**Dillon's – near the SW corner of NE Tudor Rd. & NE
Douglas St.**

**Rezoning & Preliminary Development Plan
PL2026-035**

High Impact Screening – Modification Request

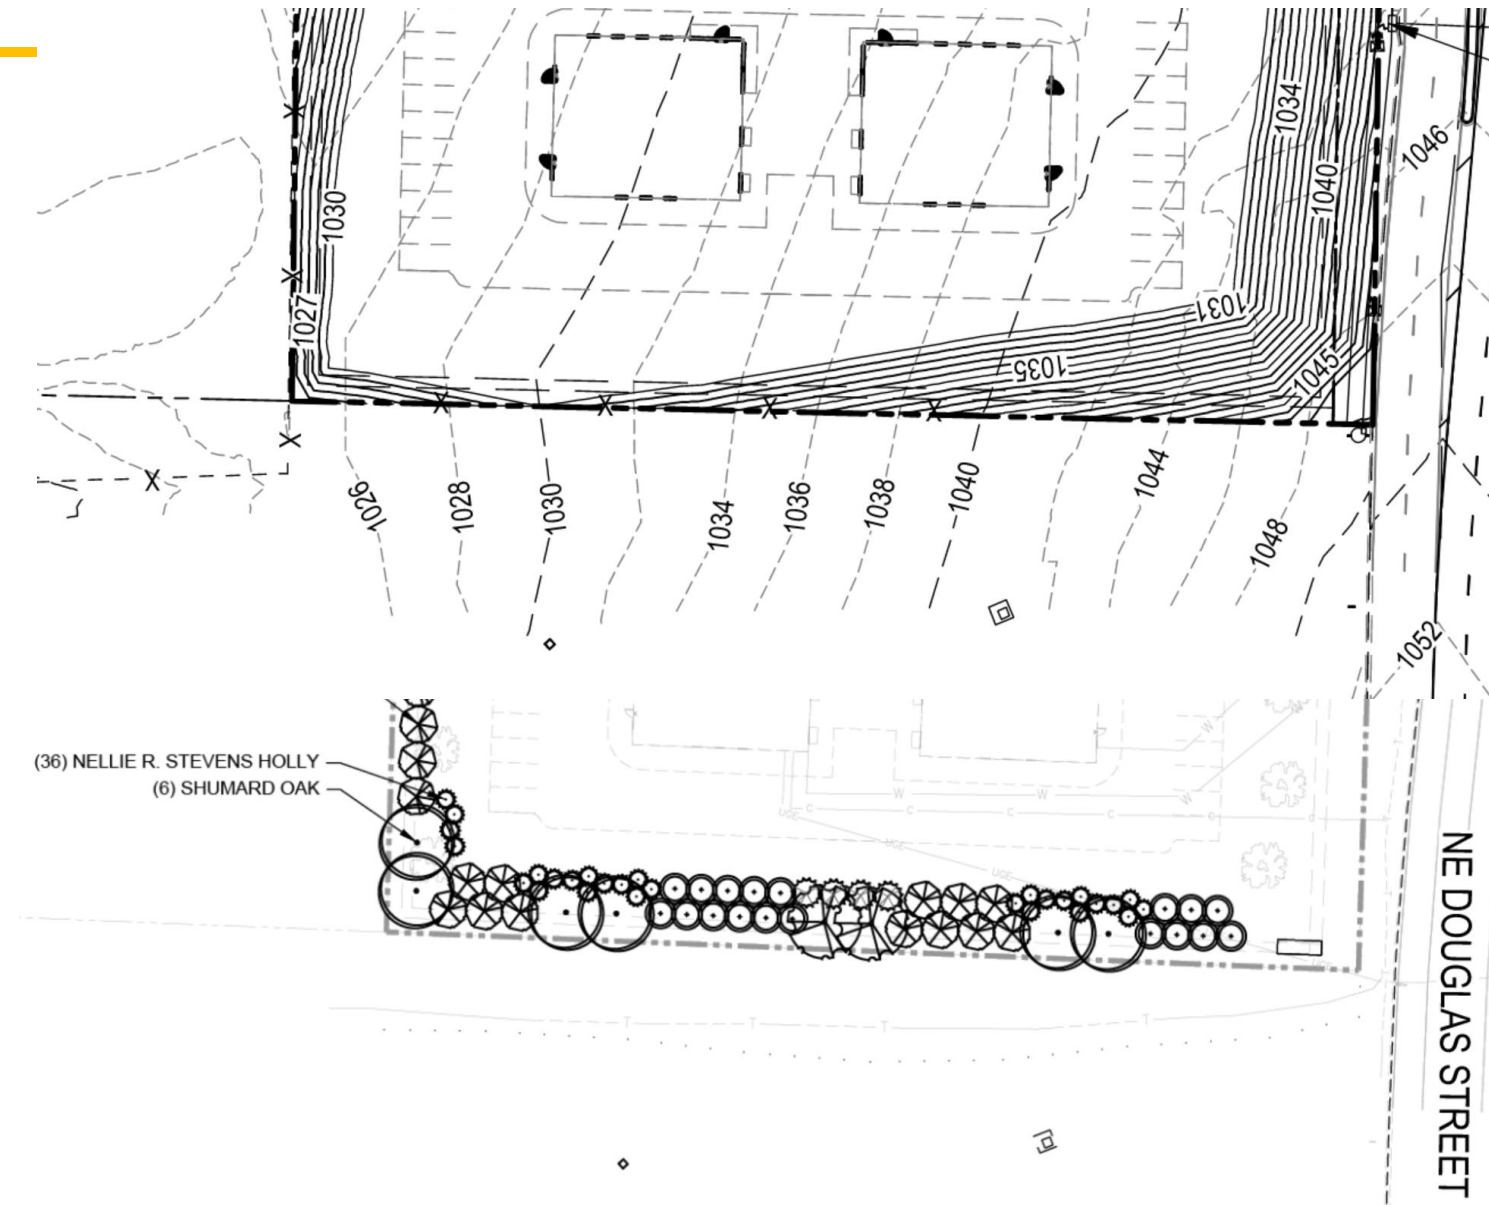
Requirement: Six-foot high masonry wall, opaque vinyl fence, or three-foot high berm, and low impact screening adjacent to AG zoning (southeast)

Proposed: The applicant is proposing to utilize the proposed grade in lieu of installing a masonry wall, vinyl fence, or berm along the southeastern portion of the property along with required landscaping.

4. A modification shall be granted to UDO Sec. 8.250.D.1 to allow for the light poles to be 28' tall from grade inclusive of the concrete base.
5. A modification shall be granted to UDO Sec. 8.900.A to allow the proposed grade in lieu of installing a masonry wall, vinyl fence, or berm along the southwestern portion of the property adjacent to the AG zoning along with required landscaping.
